## DRAWING SHEET AMENDMENTS

Three formal drawings sheets are included herewith with corrections / changes to part numbering. Please substitute each of these corrected drawing sheets with the corresponding originally filed sheet. Thank you.

FIG. 22

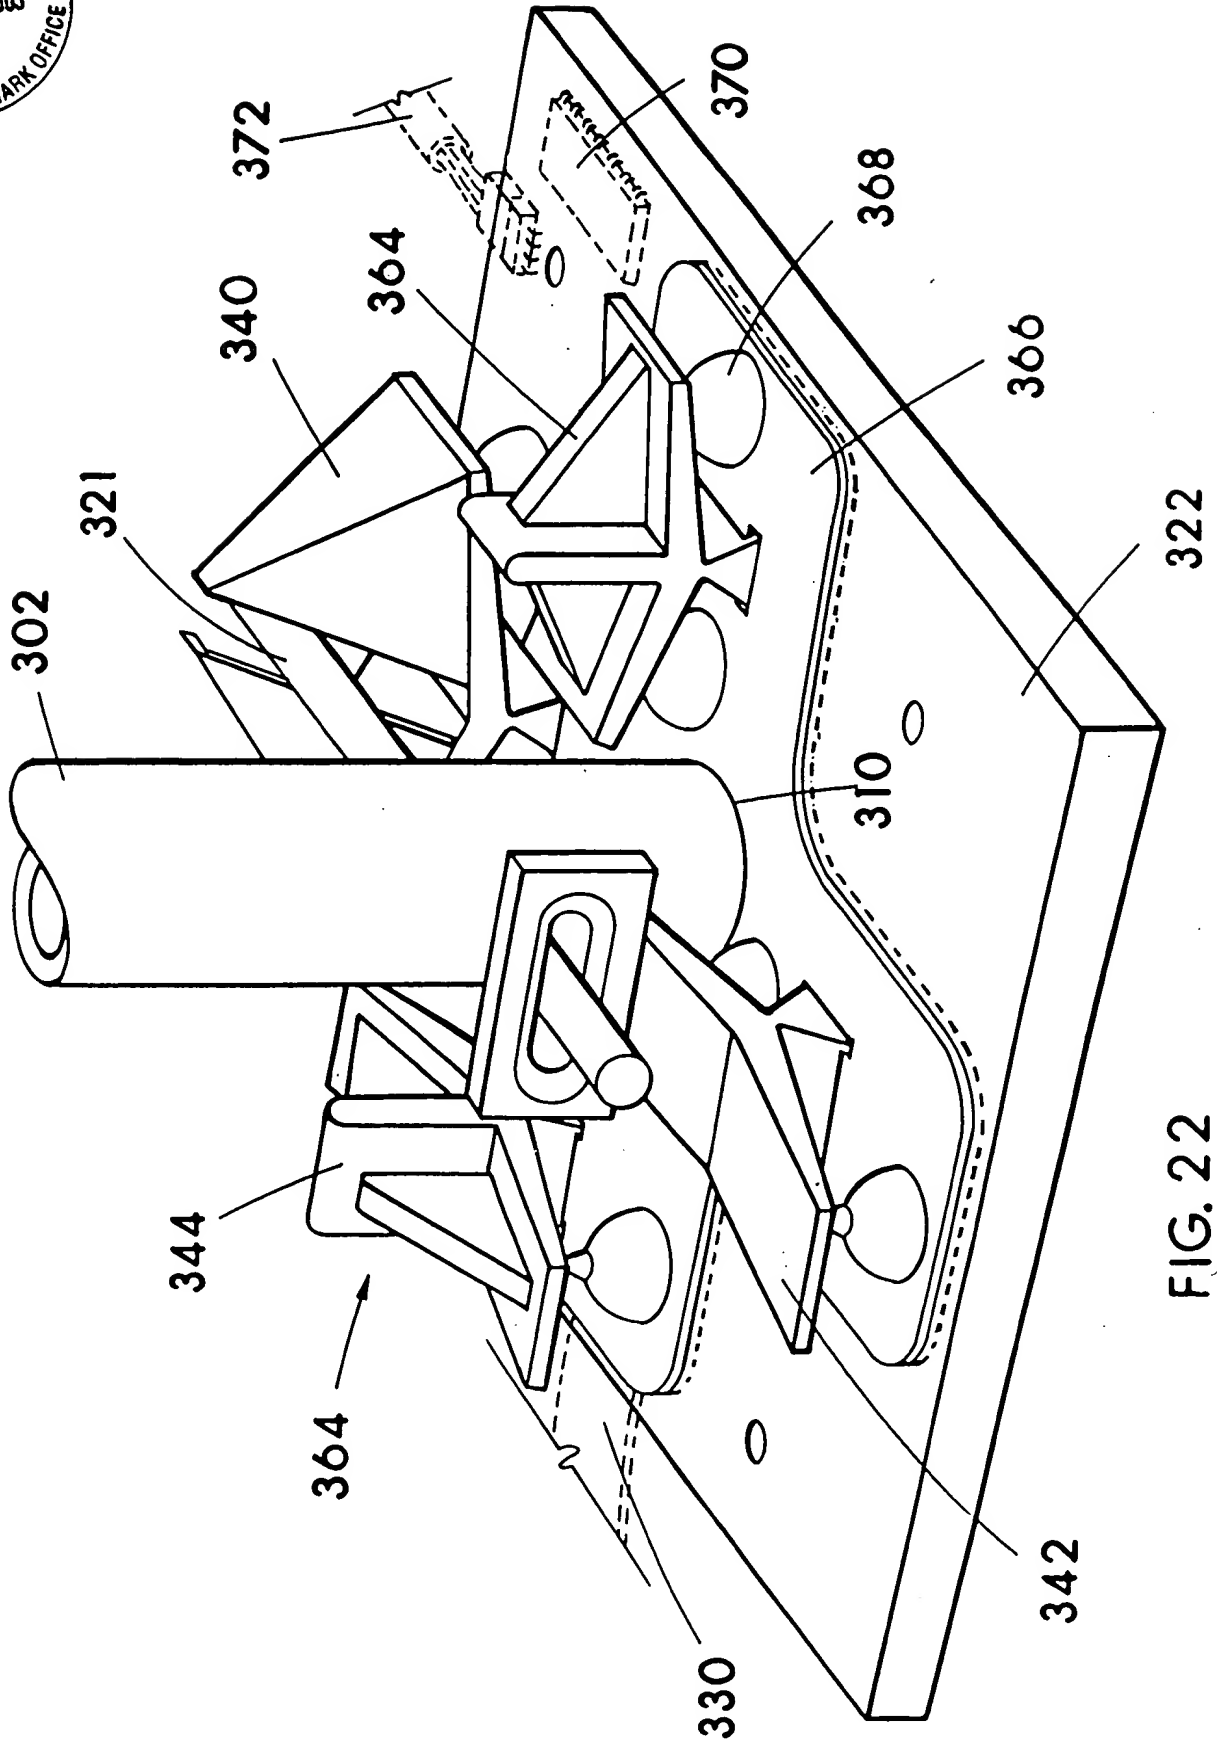
The first drawing sheet has Fig. 22 thereon. The change is that "346" on the second t-rocker has been corrected to read -- 364--.

FIG. 26

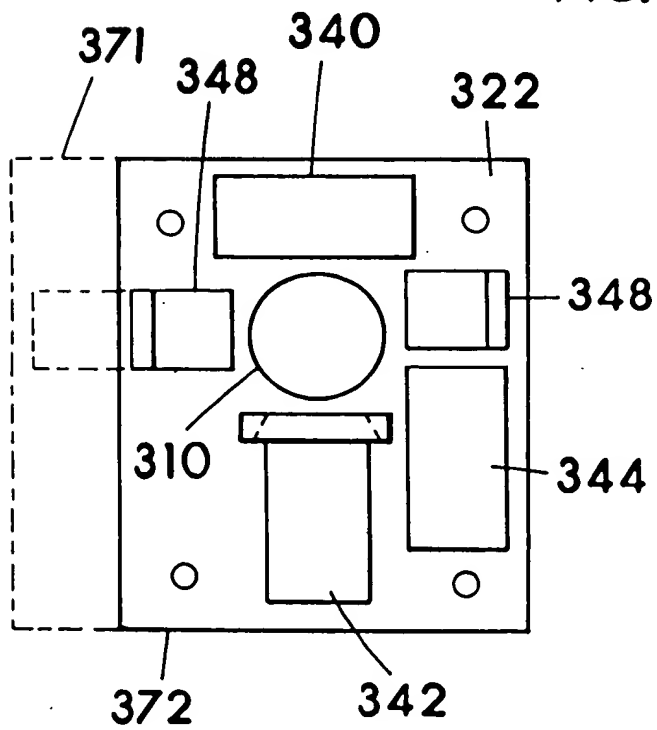
The second drawing sheet has Fig. 25, Fig. 26 and Fig. 27 thereon. The change is that "370" on the broken-line area in Fig. 26 has been corrected to read --371--.
